Attachment D: Comments on Surrender Application

RE: FOREST SERVICE COMMENTS ON THE DRAFT APPLICATION FOR SURRENDER OF LICENSE DOCUMENT FOR THE BOREL HYDROELECTRIC PROJECT, FERC PROJECT P-382

COMMENTS ON DRAFT APPLICATION FOR SURRENDER OF LICENSE

**Re: OBJECTIONS/COMMENTS of Affected Landowner, ELDARICA LAND CORP.,
to Particulars in Segment 7 of the Proposed Decommissioning by SoCalEdison of the Borel Canal,
in re: the Application for Surrender of License for Borel Hydroelectric Project, FERC Project No. 382**

Figure 2-36. School Pedestrian Bridge (Non-Project), Looking Downstream (Photo Date: 01/2020)

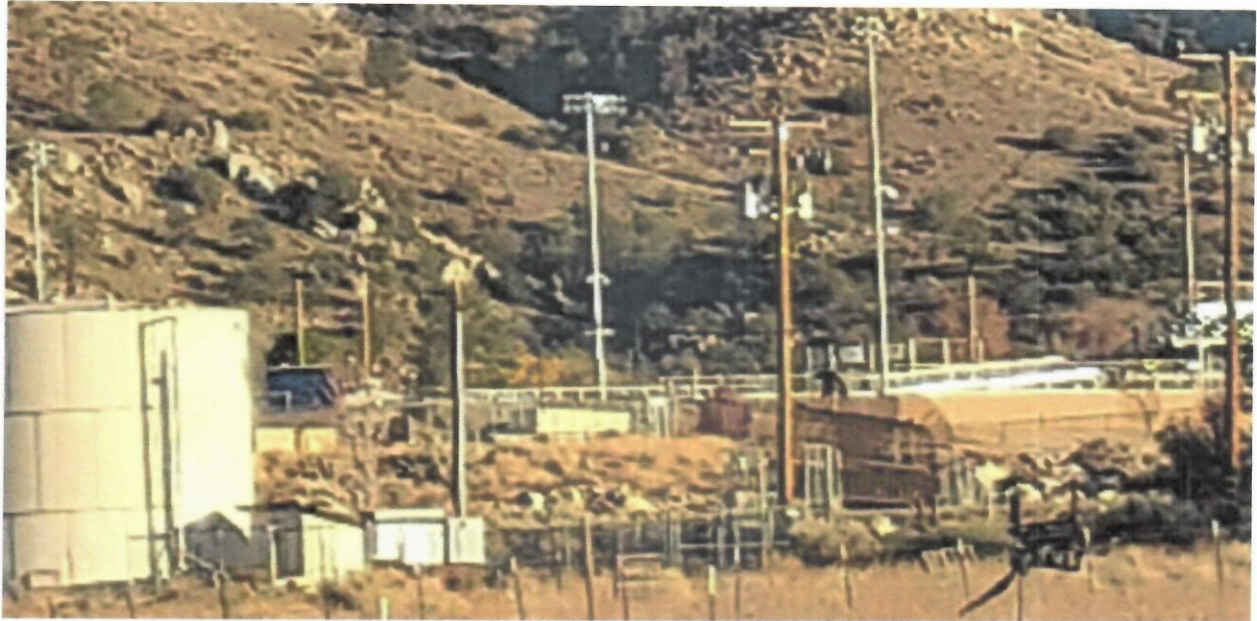
OBJECTION #1: THE “SCHOOL PEDESTRIAN BRIDGE” AT WEBB AVENUE SHOULD BE REMOVED, NOT MERELY ABANDONED IN PLACE, AS PRESENTLY PROPOSED. AFTER THE BOREL CANAL IS CLOSED, THIS BRIDGE “OVER” THE BACKFILLED FORMER CANAL WILL SERVE NO PURPOSE, AND IT WILL BECOME A DANGEROUS “ATTRACTIVE NUISANCE” FOR SCHOOL CHILDREN ATTENDING THE ADJACENT SCHOOLS, CREATING SIGNIFICANT FUTURE LIABILITY FOR SOUTHERN CALIFORNIA EDISON IF MERELY LEFT IN PLACE

The “School Pedestrian Bridge” (described in Section 2.8.1.2 of Volume II, the Decommissioning Plan) is located in Segment 7 of the proposed Decommissioning Project. This Bridge is located within an easement across Parcel [REDACTED]. The owner of record of this parcel is Eldarica Land Corporation.

The former canal will therefore be entirely backfilled and covered-over throughout its Segment 7 course, **including underneath the “School Pedestrian Bridge” itself**, which will accordingly become a useless **“Bridge to Nowhere”**. After decommissioning, the Bridge will no longer have any beneficial use/function and will become a dangerous nuisance in the heart of our community, so close to three of our schools. Especially it will become a dangerous “attractive nuisance” to the many schoolchildren who have used it to cross the Borel Canal in order to reach their three schools located immediately east of the Bridge. This is a **legal liability** which Southern California Edison should avoid by **removing this bridge altogether**.

There is no reason for this former “Bridge” to remain, and every justification that it should be removed. Edison is thus requested to remove this Bridge, and not to “abandon it in place” as Edison proposes.

No. This allegation is FALSE. What about the SCHOOL PEDESTRIAN BRIDGE? That is not proposed for either (a) abandonment with modification or (b) removal. It is being **ABANDONED IN PLACE** by Edison. Edison needs to **REMOVE the SCHOOL PEDESTRIAN BRIDGE**, not dishonor its clear decommissioning responsibilities by abandoning the School Pedestrian Bridge in place, leaving this dangerous eyesore.
